CITY OF CONWAY, ARKANSAS HISTORIC DISTRICT COMMISSION

August 26, 2024 • 5:30pm • 1111 Main Street

NEW DRIVEWAY

ADDITION

1904 Robinson Ave

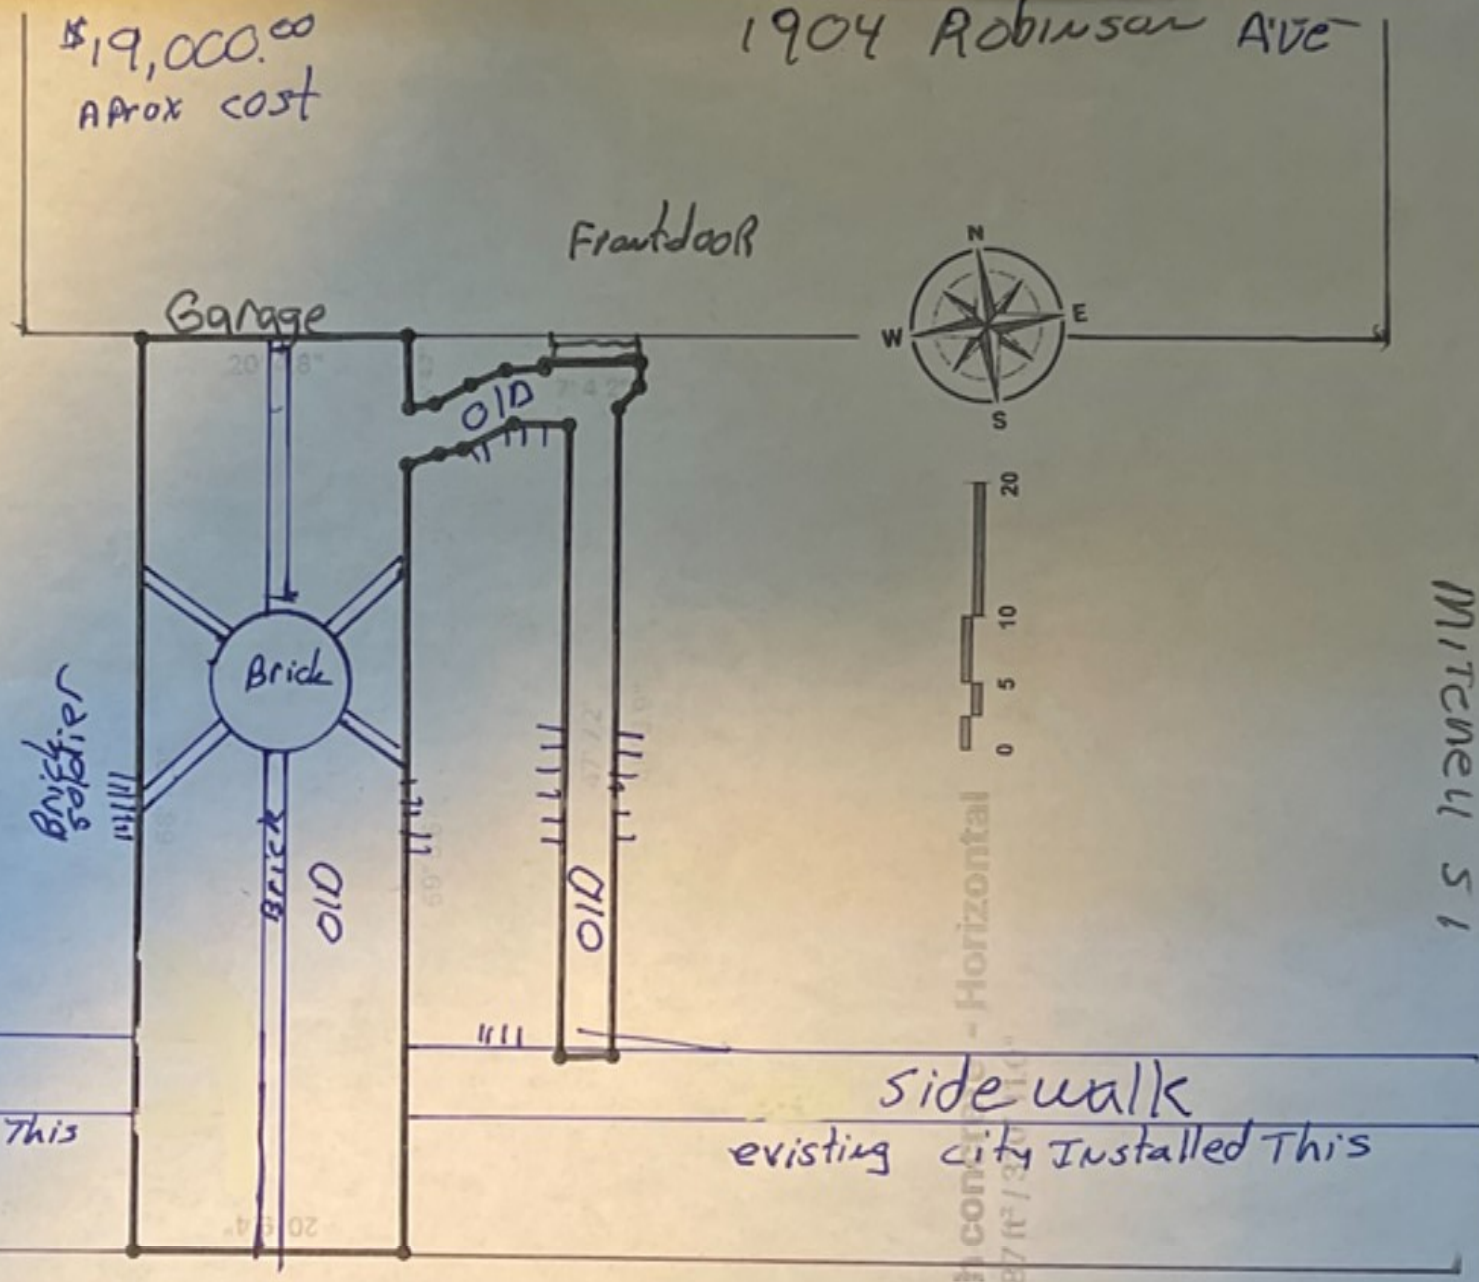
The new driveway design and configuration will not alter the topography or natural features of the site. Any changes to the sidewalk shall match the adjacent sidewalk. The existing driveway is concrete and terminates at the garage. The garage is noted as an addition in the 2020 survey document.

The existing driveway is not historic. The proposed brick accents will complement the architectural features of the residence, be eye catching from the public realm, and will lend a historical credence to the drive. The

accents are not anachronistic with the building or historic district.

The proposal conforms with less than 50% impermeable surface in the front yard, the location is compatible, and the materials are appropriate.

Staff recommends approval of the application with the following conditions:

1. Driveway shall be installed according to the design provided in the application/certificate of appropriateness.
2. Driveway and parking area shall be composed of brick and concrete. It may not exceed 50% of the front yard.
3. If the existing sidewalk is damaged during construction, it must be repaired.

803 HARKRIDER, SUITES 11 & 12
CONWAY, ARKANSAS

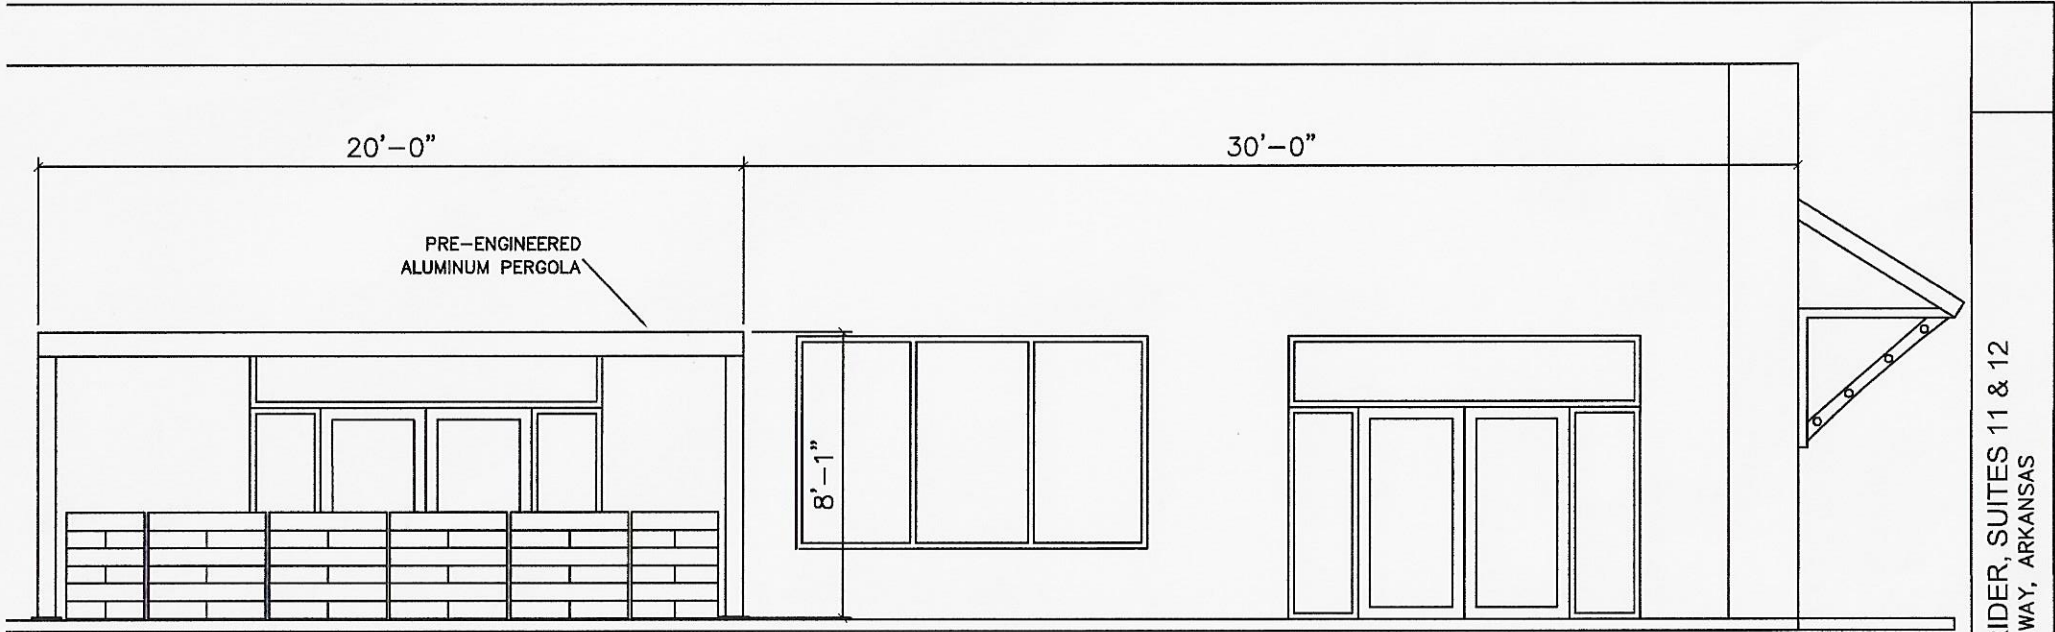
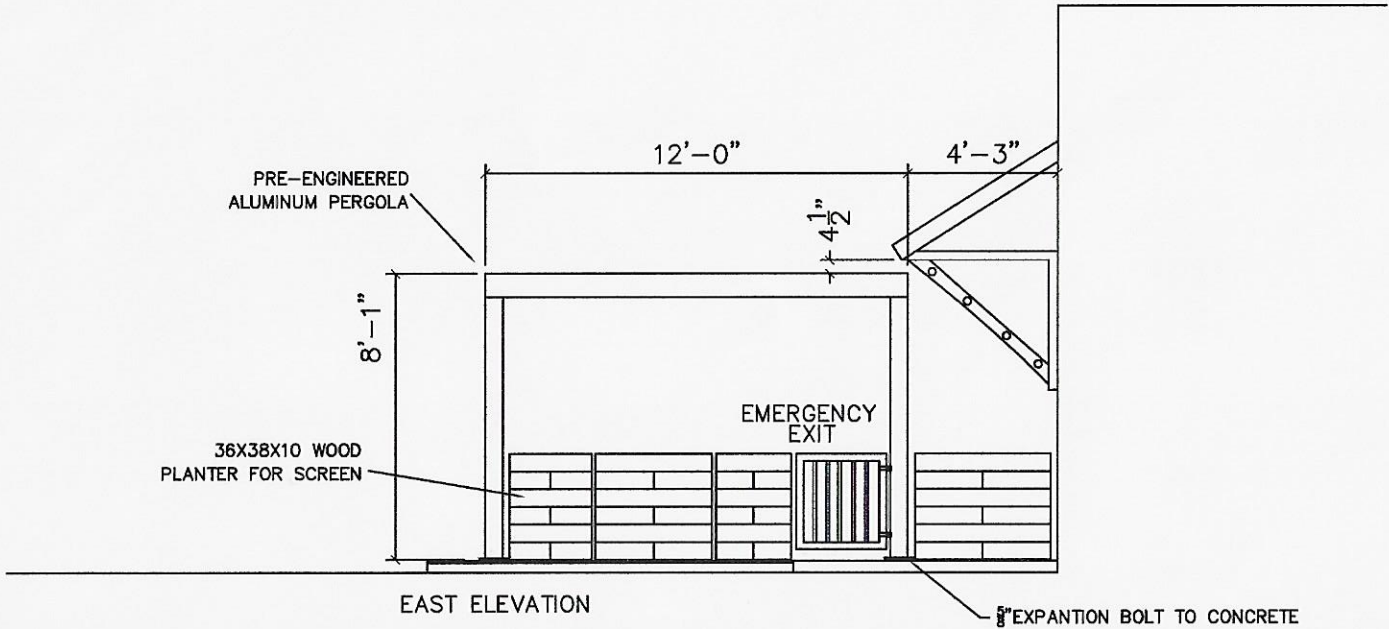
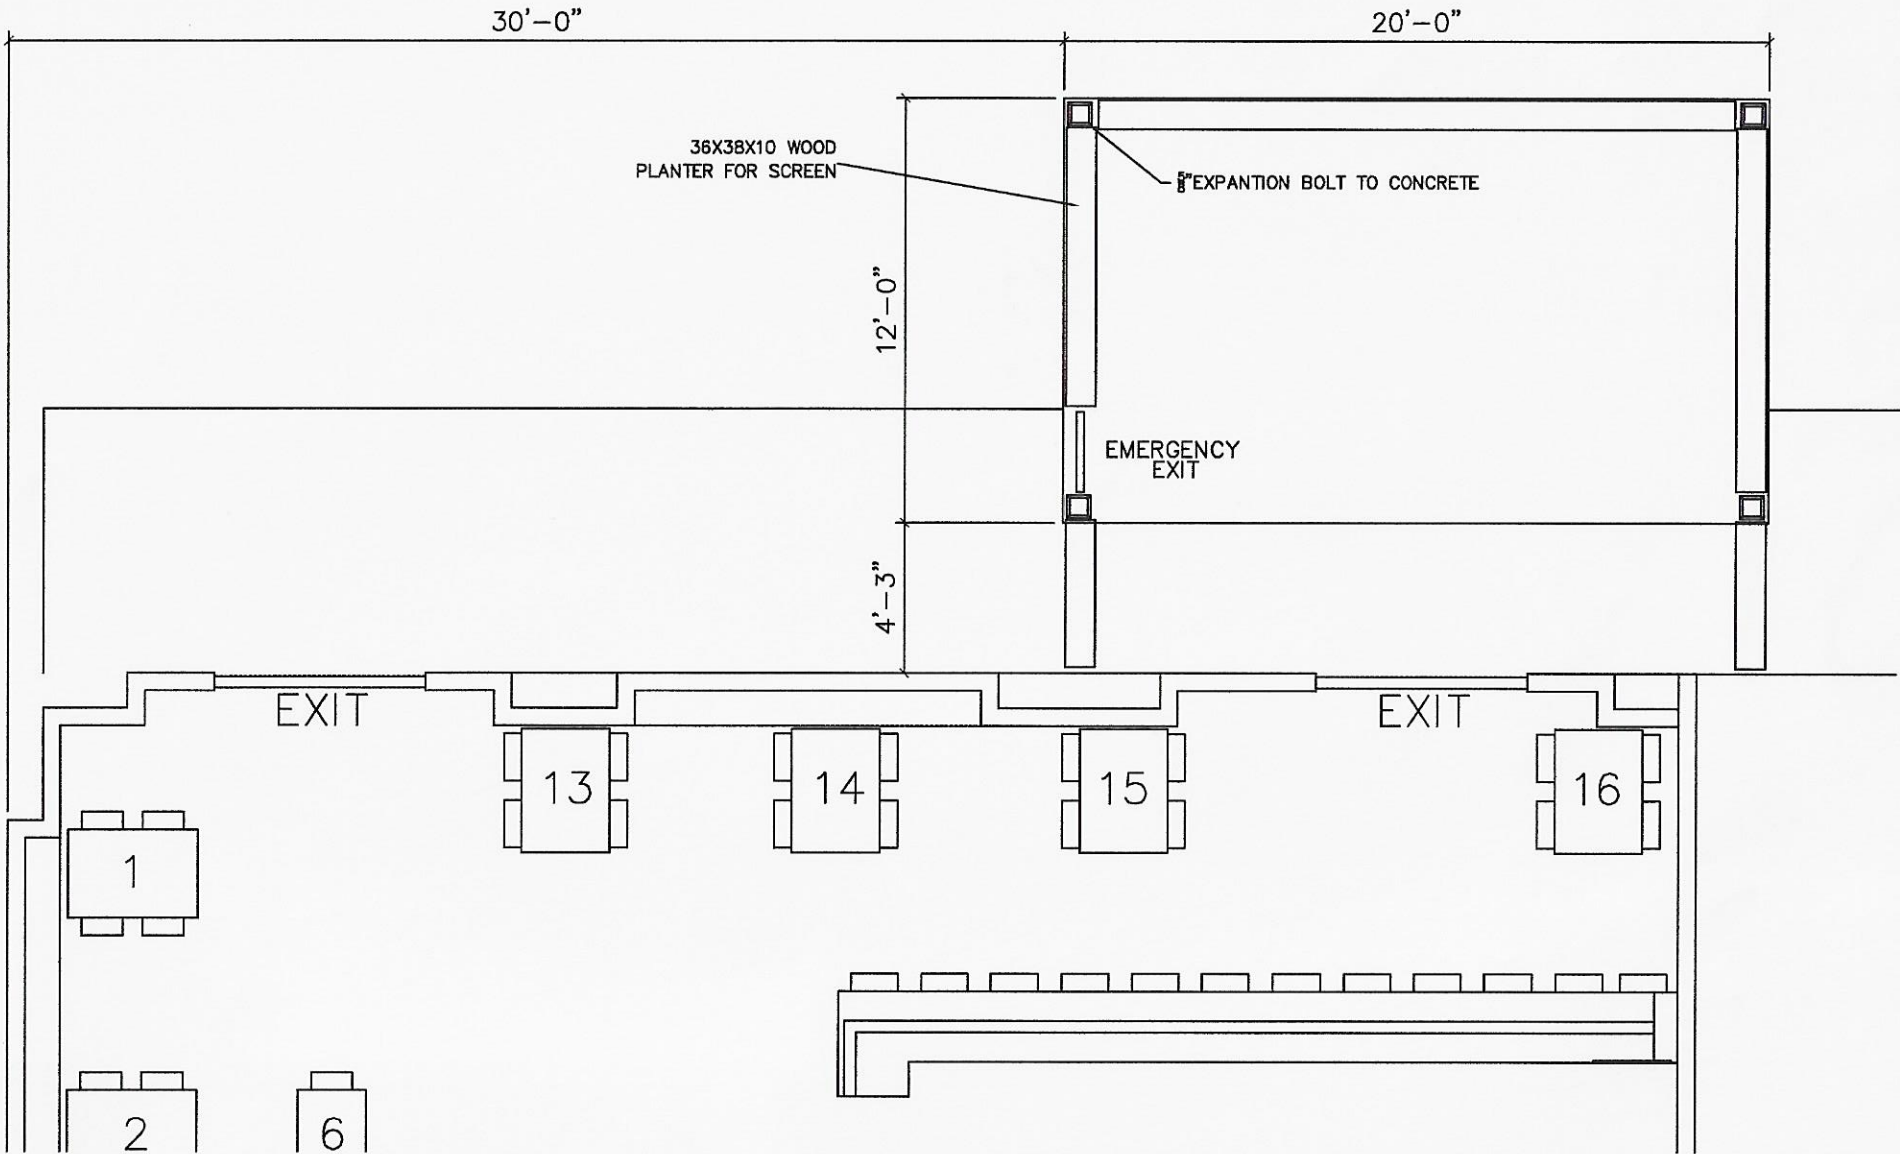
Proposal includes wood planters for screening instead of fencing.

Outside seating area enhances the façade articulation by adding variation to the roofline as well as along the wood planters.

Applicant is proposing to use a pre-engineered aluminum pergola for the roof and a wood planter for screening. Access to the restaurant from the outdoor seating area is an existing commercial glass door.

The proposed pergola is 8' above the finished grade.

Lighting is not indicated on the submitted plans.

The proposal is for a seating area on the west side of an existing structure. It will be outside of the public right of way in what are existing parking spots. It will consume a maximum of three parking spots.

Staff recommends approval of the proposed outdoor seating with the following conditions:

1. Applicant must obtain all applicable building permits* if/when a Certificate of Appropriateness is granted.

2. The pergola roof shall be no less than 8' above finished grade.
3. Lighting may not encroach into adjacent businesses.
4. Vegetation in planter boxes must be maintained.
5. Pergola must have a semi-open roof, be constructed of fire-resistant material, and be affixed to the existing structure (i.e. bolted to the awning).
